REF: Wall Section in Reactor Coolant Pump Casing Below Minimum
Design Requirements

BELLEFONTE NUCLEAR PLANT UNIT 1 - REPORTABLE DEFICIENCY - WALL
SECTION IN REACTOR COOLANT PUMP CASING BELOW MINIMUM DRAWING
REQUIREMENT - CONTROL NO. HO 1074 F2 - FINAL REPORT

BELLEFONTE NUCLEAR PLANT WALL THICKNESS IN REACTOR COOLANT PUMP (RCP) CASING BELOW MINIMUM DRAWING REQUIREMENT

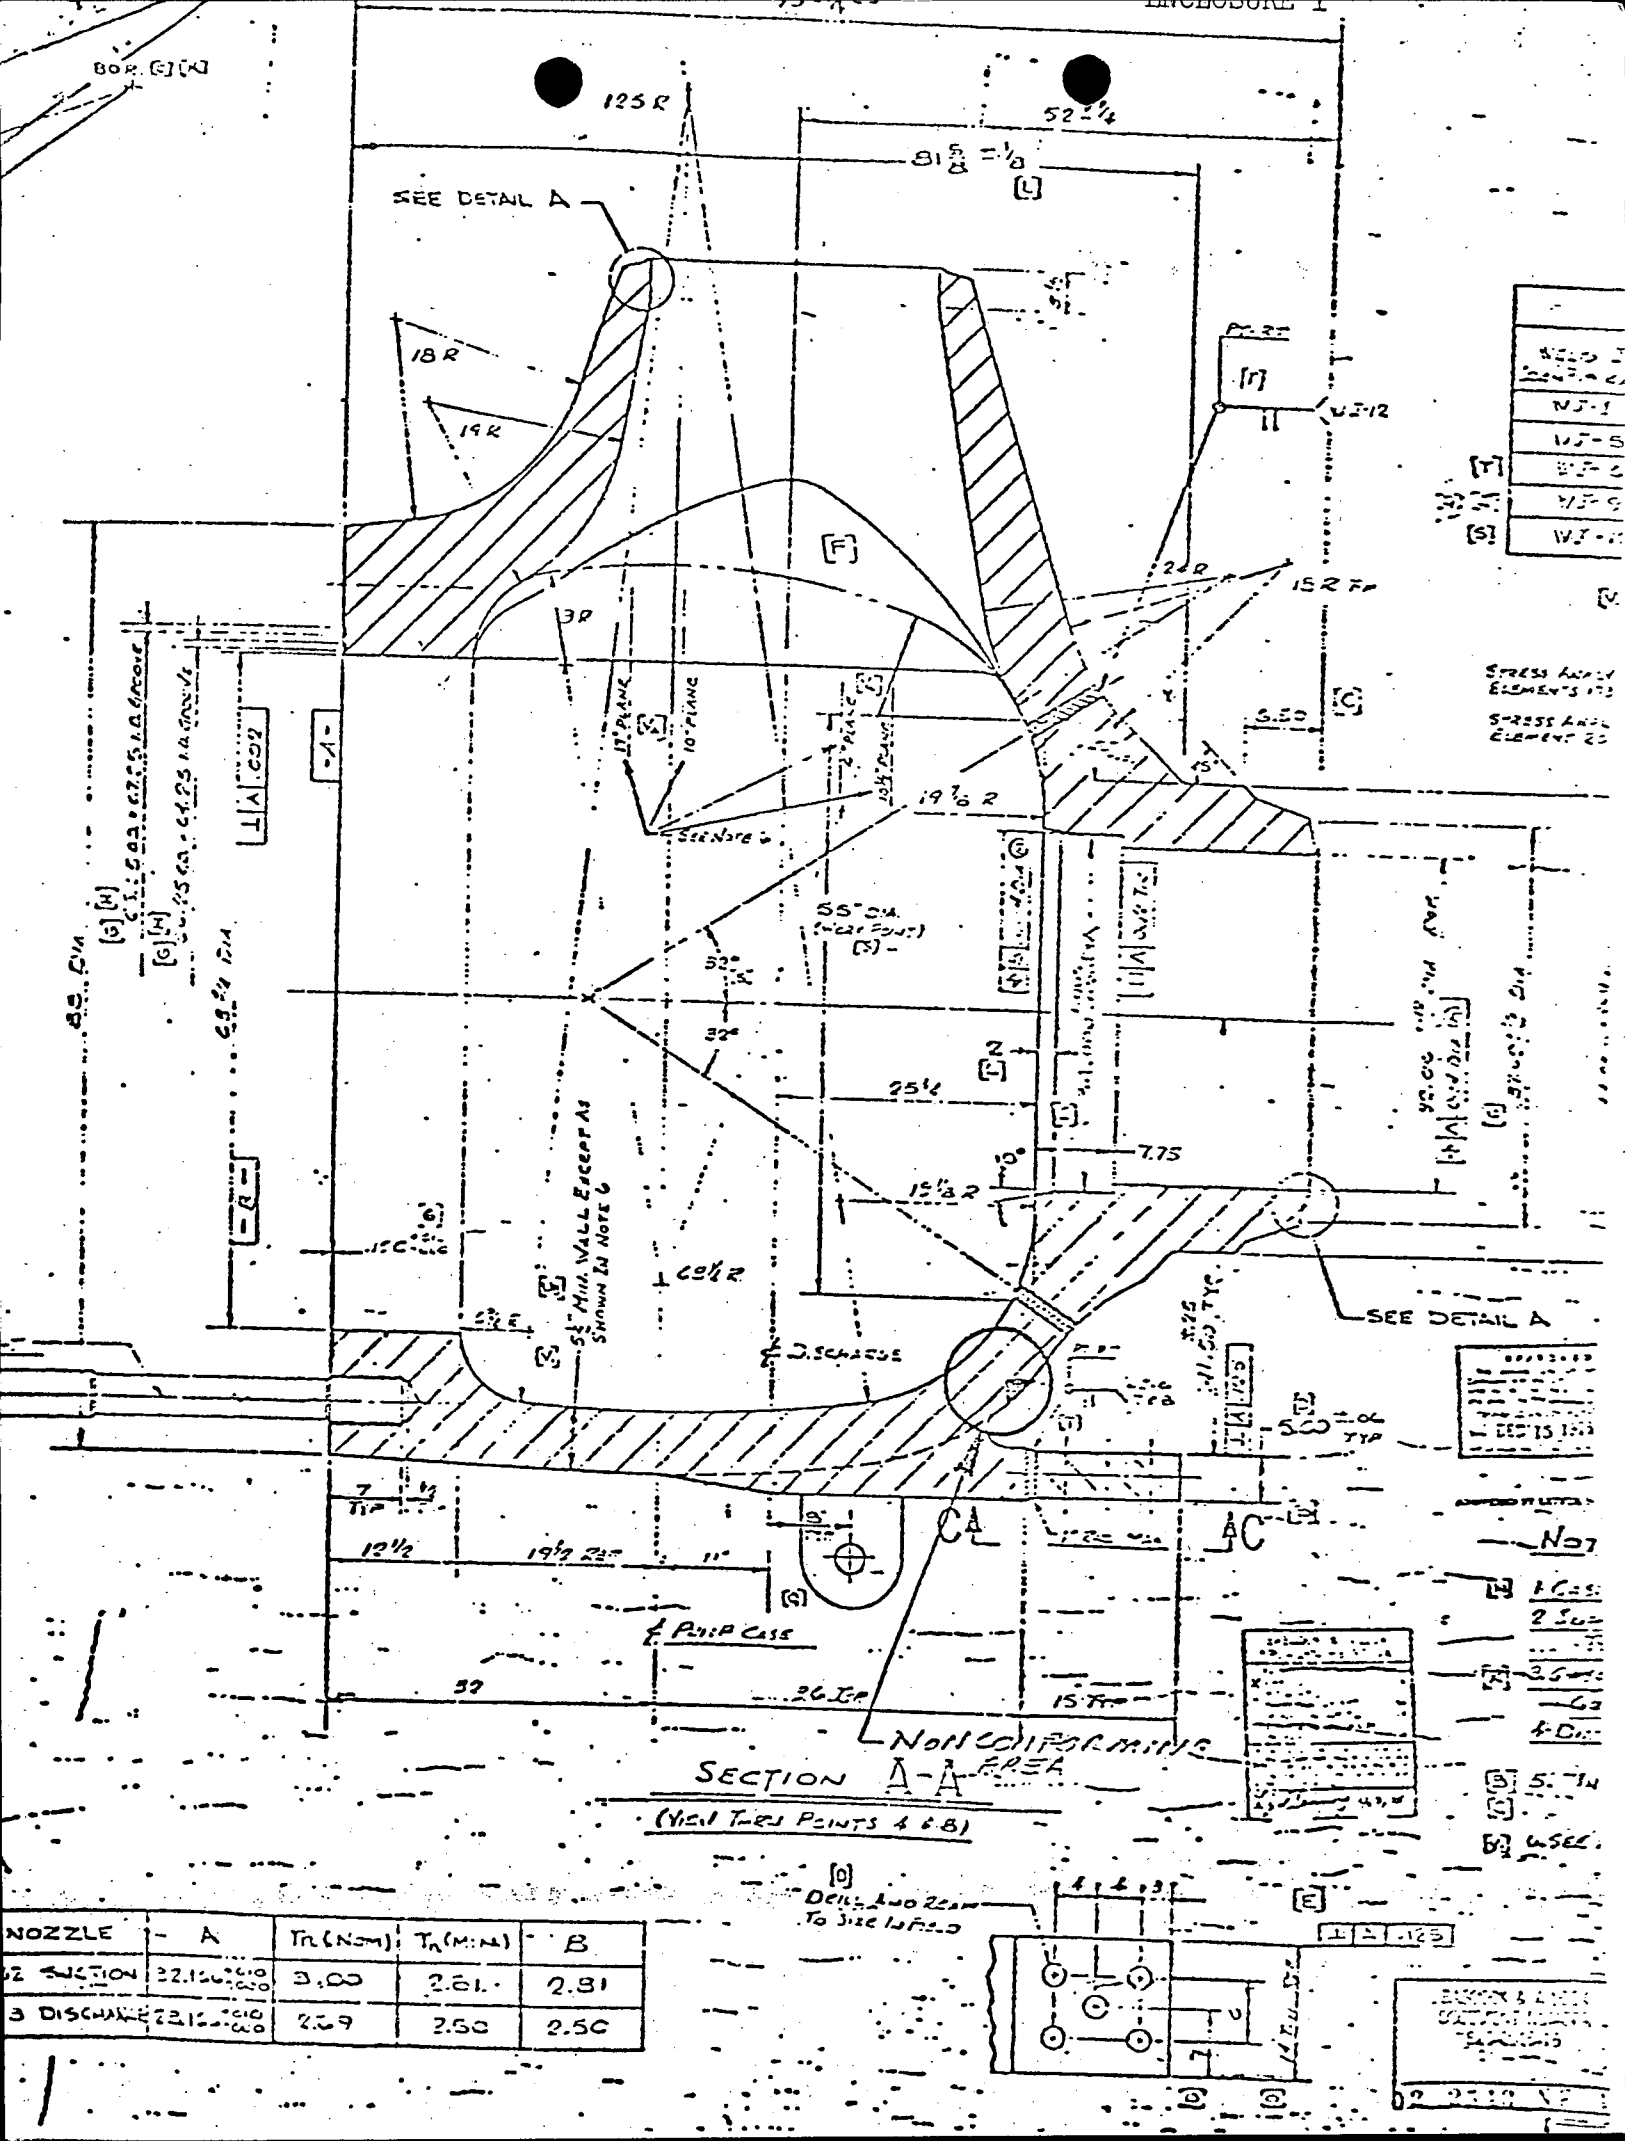
Reactor Coolant Pump casing, S/N-501, is nonconforming in that an area approximately 3-1/2 inches wide by 16 inches long had been ground out leaving a minimum wall thickness of approximately 4-1/2 inches. The minimum drawing requirement is 5-1/2 inches. Attachment 1, Babcock and Wilcox drawing 02-2543NF-15, is marked to show the area of nonconformance.

The casing was being manufactured by Bingham-Williamette Company (BWC), Portland, Oregon, for the Bellefonte nuclear steam system supplier, Babcock and Wilcox. The deficiency occurred when ESCO, a subcontractor to Bingham-Williamette, removed the material to enable proper positioning of electroslag welding equipment for welding the restraint lug to the restraint boss.

The ground-out area of pump casing No. 1 (S/N-501) has been repaired by weld buildup and blended with the original contour of the casing.
